43A Redington Road &
NW3 7RA

Basement Impact Assessment
Audit

For
London Borough of Camden

Project Number: 13693-21
Revision: D1

Lost Rivers Locations

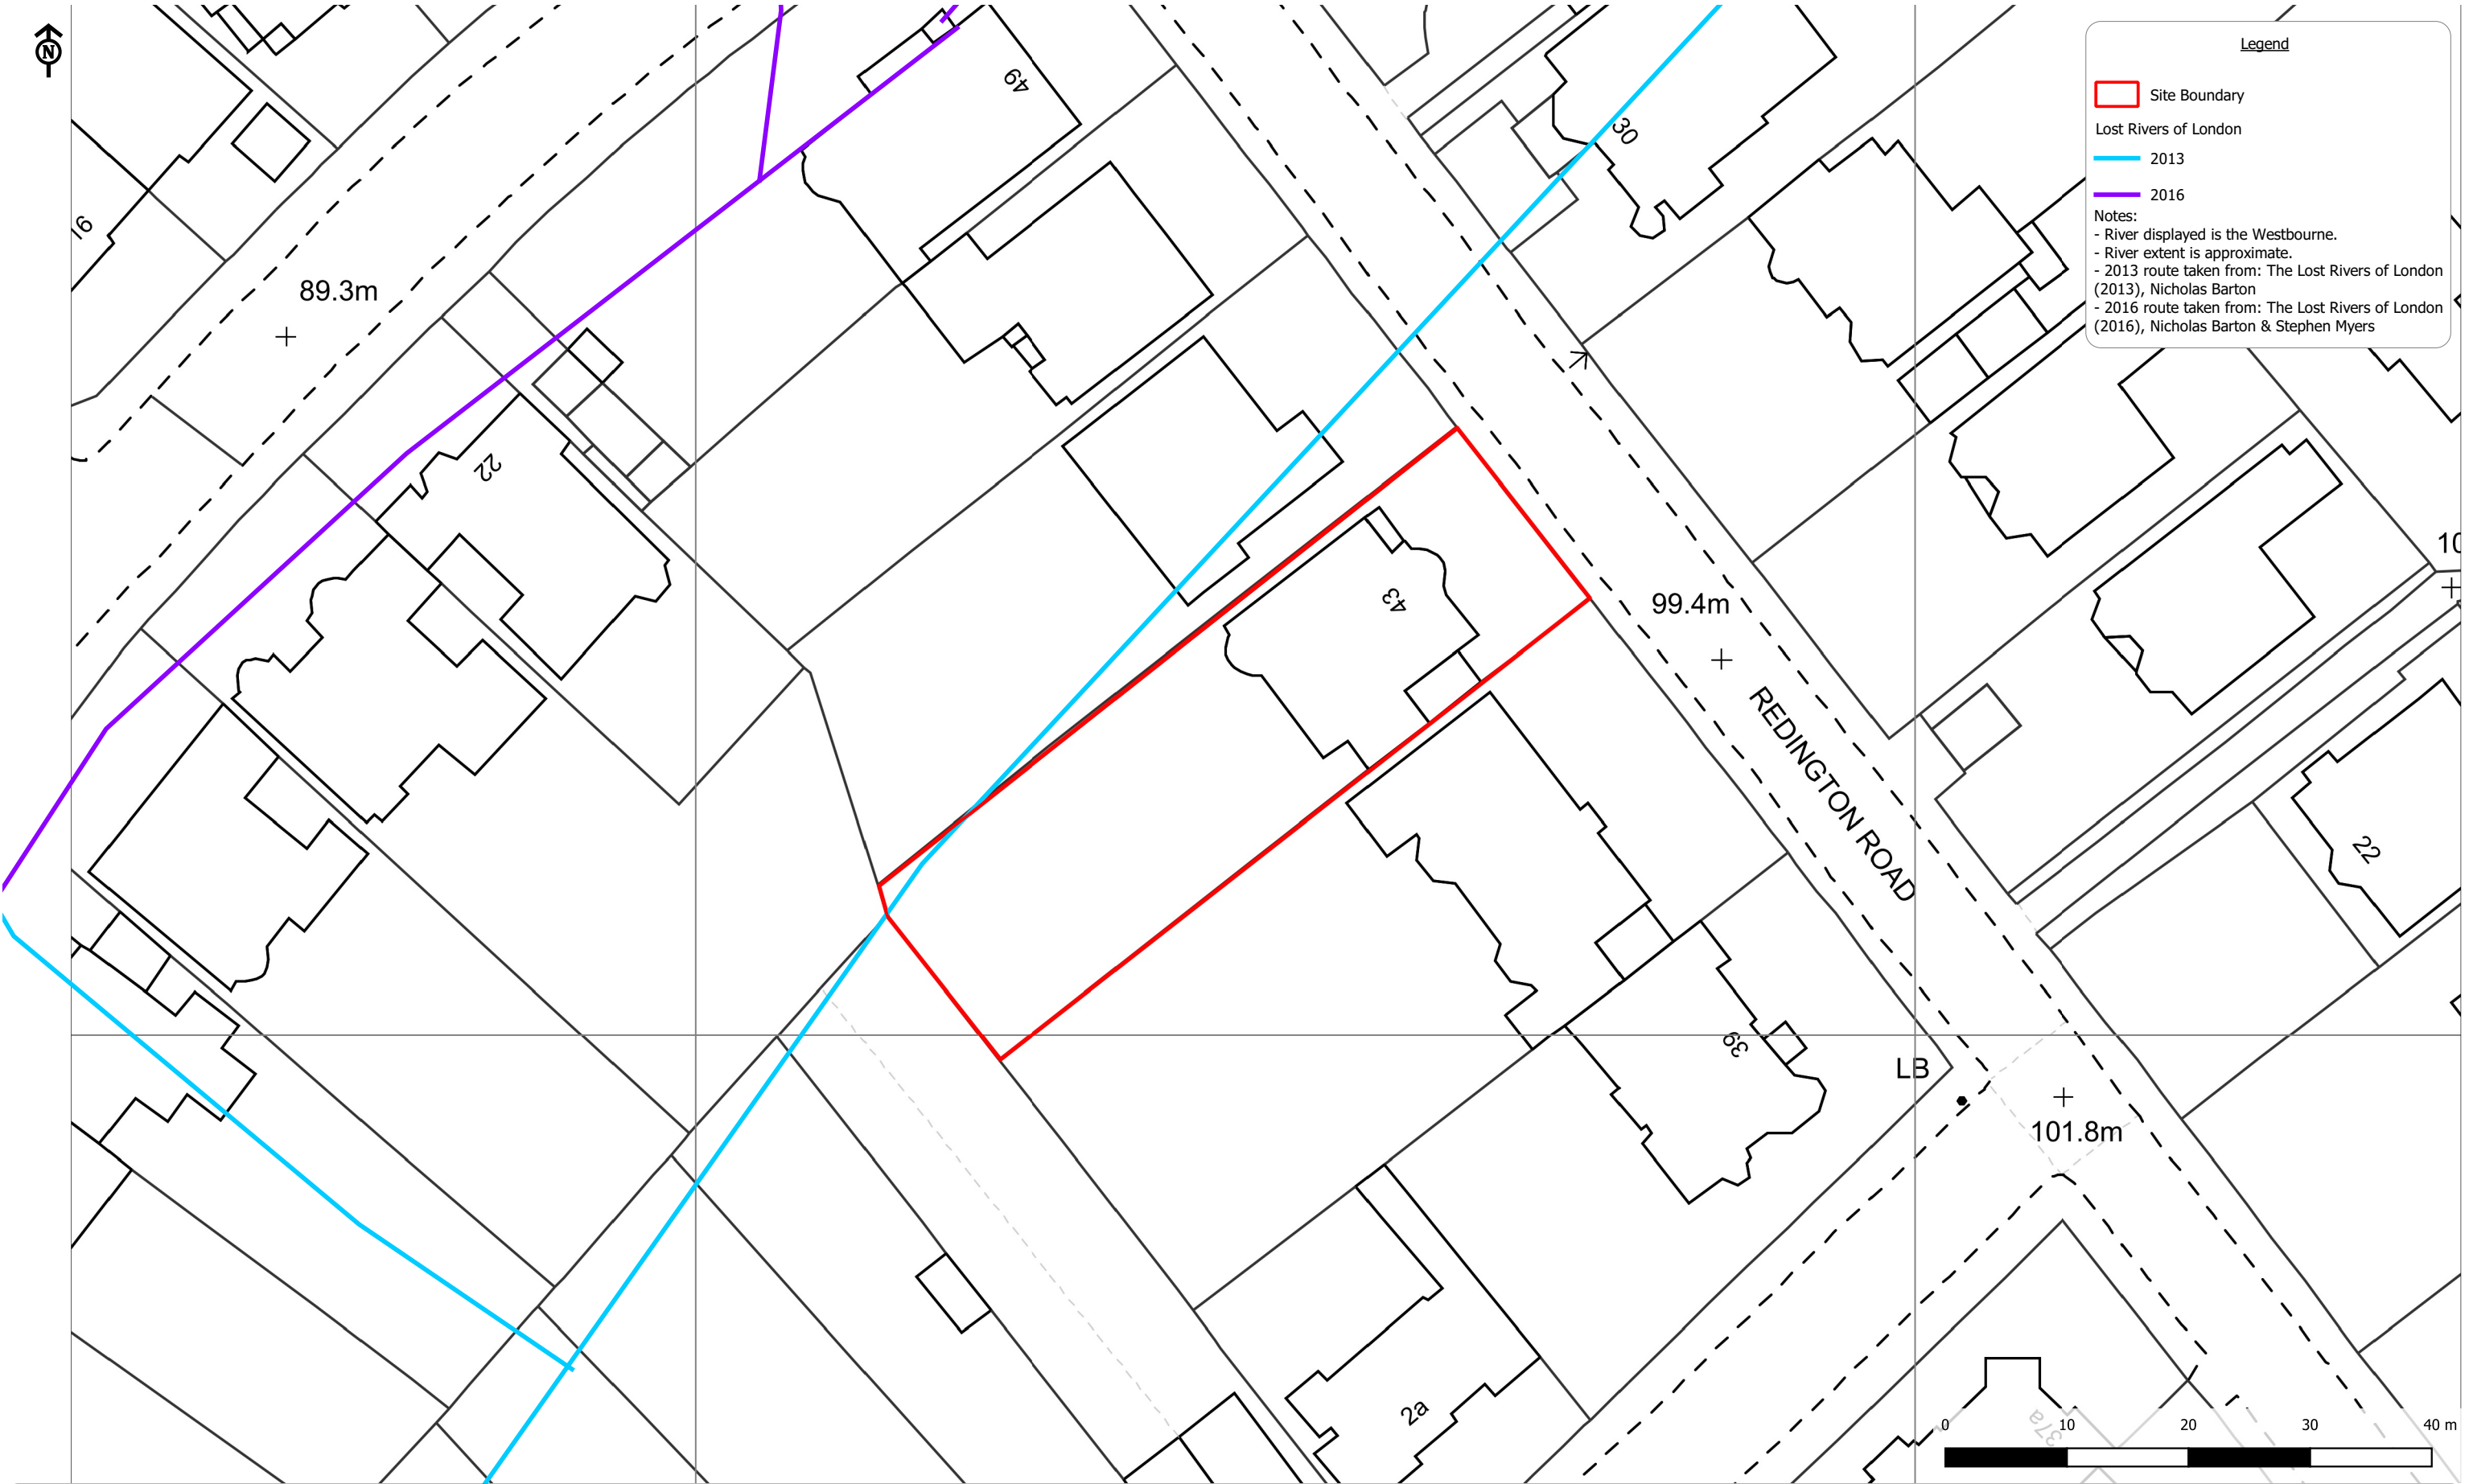
- 4.12. In accordance with London Lost Rivers 2016 (Barton & Meyers, 2016) the BIA states that a lost river (Westbourne) is located approximately 60m away from the property. However, in accordance with Lost Rivers 2013 (Barton, 2013) the Westbourne River is indicated running adjacent to the property (see figure in Appendix 3). There is the potential to encounter alluvial deposits associated with the river during the excavation and consideration of potential impacts and contingency mitigation measures should be presented in the BIA.
